QUEENSLAND COMPETITION AUTHORITY

RURAL IRRIGATION PRICE REVIEW 2020-24

ASSESSMENT OF HYDROLOGIC FACTORS: FURTHER ASSESSMENT - CENTRAL BRISBANE

WS0895.1901.001
WS190095
3
28 January 2020

Figure 3-1 – Comparison of Storage Volume Sequences Used in HUF Calculations

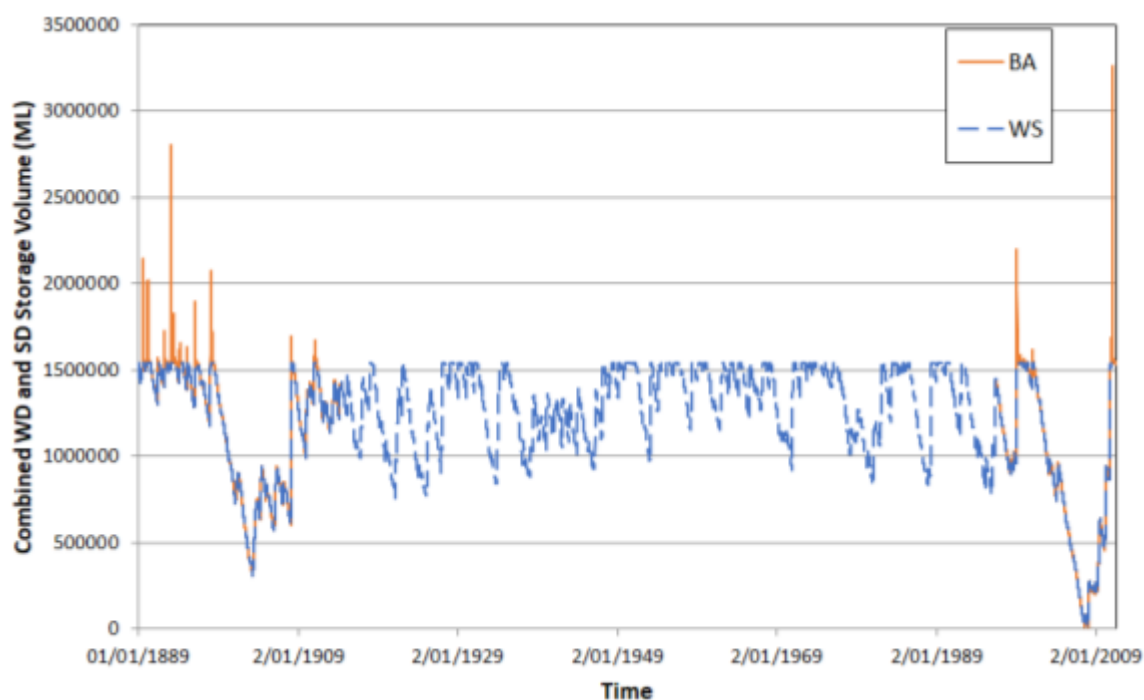
To further complicate matters, the spreadsheet also contain two daily sequences of storage levels for the period 1996 to 2011, one set labelled as coming from the IQQM model, and the other labelled as actual values. The actual 1996-2011 data has a slightly higher summed volume than the modelled 1899-2014 period, but the modelled 1996-2011 data has a significantly lower summed volume. The critical period should perhaps have been defined as 1996-2011 based on the data and the lowest sum criteria.

It is also noted that the storage volumes used in the critical periods go well above the FSV of the storages. For example, the highest combined storage volume from the IQQM model is 3.3E6 ML in Jan 2011, over double the combined FSV of the two dams at 1.5E6 ML. These volumes tend to

quickly reduce as the flood recedes, but counting water in the dams above FSV as part of the estimation of the driest period for water supply purposes may bias the result¹.

Finally, it appears that the intent in the Badu Advisory report was to determine the driest period based on the lowest summed daily volume over 15 year periods. The current methodology applied by Sunwater, as documented in Sunwater 2018j, determines the appropriate 15 year periods by estimating the HUF for rolling 15 year periods through the entire time series, and selects the driest period based on the one which produces the lowest HUF. There is no guarantee that these two methods will select the same period (especially when one is counting volume over storage FSVs).

A comparison of the combined storage volume sequences used in the Badu Advisory and WS HUF calculation is provided in Figure 3-1. (Note Badu Advisory data was only provided for the 1889-2014 and 1996-2011 periods). It can be seen that the sequences are basically identical, except for the capping to FSV undertaken in the WS calculations. It is also noted that the 2000's drought drops the combined storage volume to a much lower level, but the 1900's drought persists for slightly longer period (evaluated by the length of time between reaching FSV).

Figure 3-2 – Comparison of Exceedance Plots

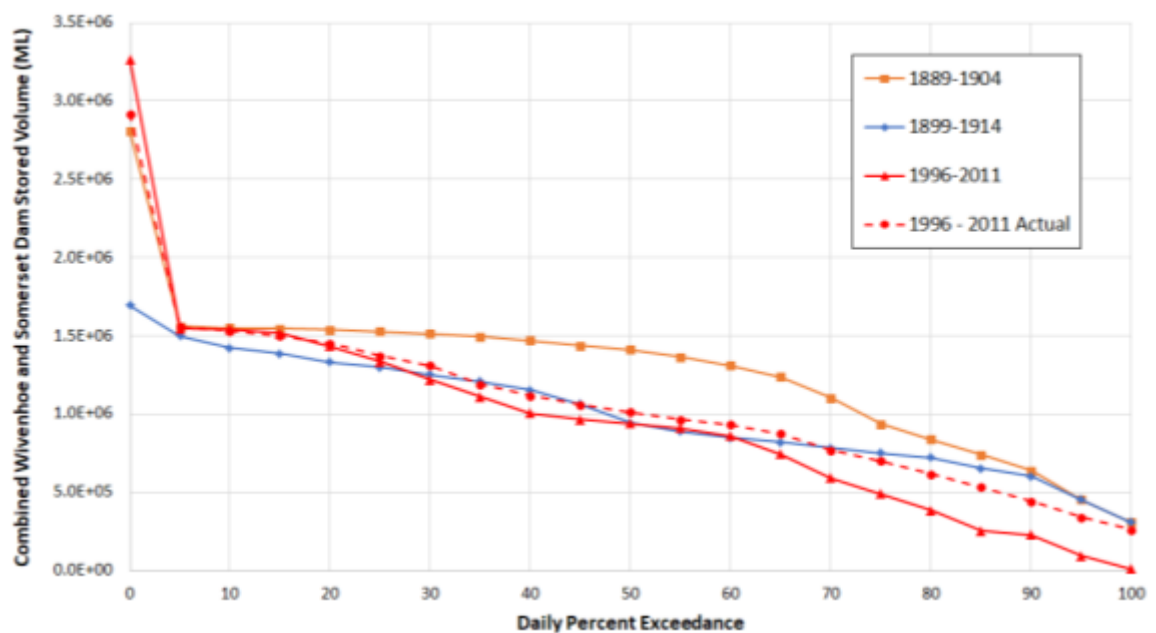
Figure 3-2 provides a comparison of the original driest period daily volume exceedance plot included in the Badu Advisory Oct 2019 report (the orange line, for the period 1889-1904), to daily volume exceedance traces for the 1899- 1914 period and 1996-2011 periods. Note all these three lines are based on modelled data. The fourth line is the 1996-2011 actual data included in the Badu Advisory spreadsheet. (Note all four data series include volumes above the combined FSV of 1.5E6 ML)

It can be seen that the 1899-1914 period is substantially drier than the 1889-1904 period, and that 1899-1914 and the actual 1996-2011 periods are similar. The modelled 1996 – 2011 period is a little higher in the wet part of this period, but significantly lower in the dry part of this period.

In summary, including dam volumes above FSV in the selection of the driest 15 year period is not considered good practice and is thus not supported. Additionally, the error in the selection of the driest 15 year period would need to be addressed, however the methodology used to select this period also has issues, see Section 3.8 for further discussion.

Figure 3-4 – Badu Advisory’s Modified HUF Parameters for Central Brisbane

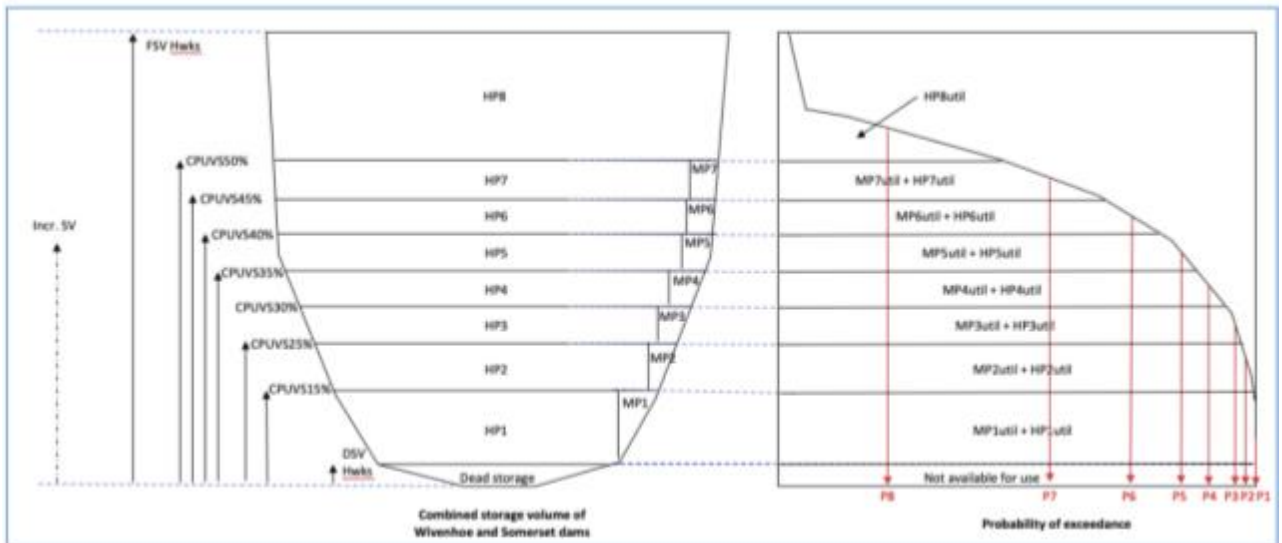
Badu Advisory’s method assigns the entire upper section of the storage to HP (zone HP8 on Figure 3-4). This appears to be a significant departure from the documented standard HUF methodology in Sunwater 2018j, and is thus not supported.

Badu Advisory has subdivided the standard HUF methodology Zone MP1² (ref Figure 3-3) into a number of layers based on the AA rule specified for the Central Brisbane WSS in the Operational Manual. Table 3.2 shows the core AA rule from that Operations Manual, where the MP AA is determined based on CPUVS.

Badu Advisory has attempted to allow for each row of this table individually, with Badu Advisory’s conceptual approach illustrated in Figure 1 of Badu Advisory’s report, shown below for convenience.

The approach taken in WS Sept 2017 appears to be more in keeping with the standard HUF procedure documented in SunWater 2018j. For example, page A-7 and page A-8 outlines the steps for calculating MP0 and MP100, which defines the top and bottom of the middle zone. Of course all schemes with AA rules do, from time to time, announce an allocation between 0% and 100%, but the standard procedure does not require calculation of separate zones for intermediate MP AA values. The Central Brisbane AA rule uses a different method of calculation, but the outcome is the same – MP AA’s are announced each year at values between 0% and 100%, the same as most other schemes. As per the discussion in Section 3.3, there does not appear to be a substantial difference here which would warrant a departure from the adopted standard MP to HP conversion methodology.

It is thus recommended that the standard HUF approach of only creating a horizontal storage slice at 0% and 100% MP AA is maintained for the Central Brisbane in this price review.

Figure 3-5 – Modified HUF Parameters for Central Brisbane

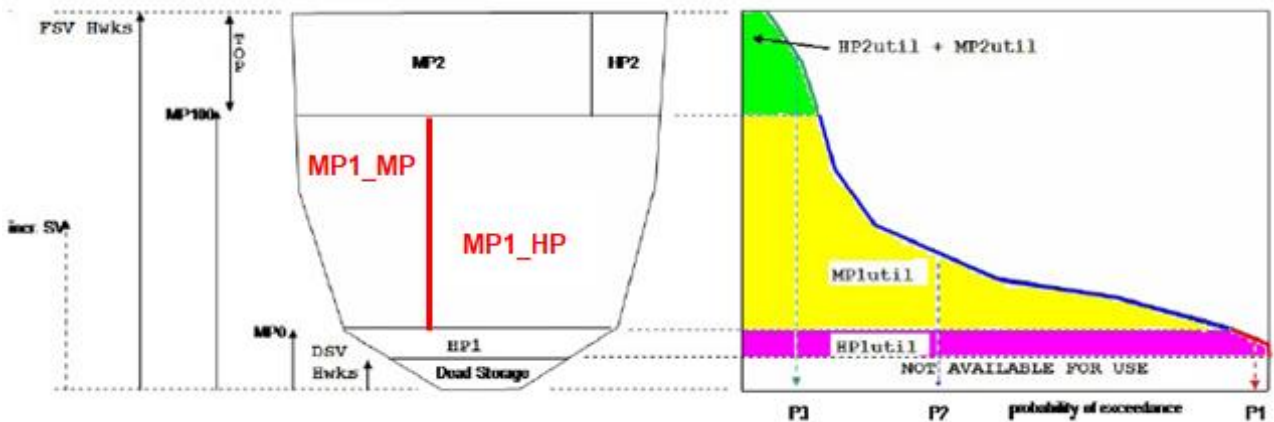
WS also based its subdivision of the MP1 zone on the AA rule in the Operations Manual, but took a simpler approach, subdividing the middle zone into the parts for HP and MP, see Figure 3-5.
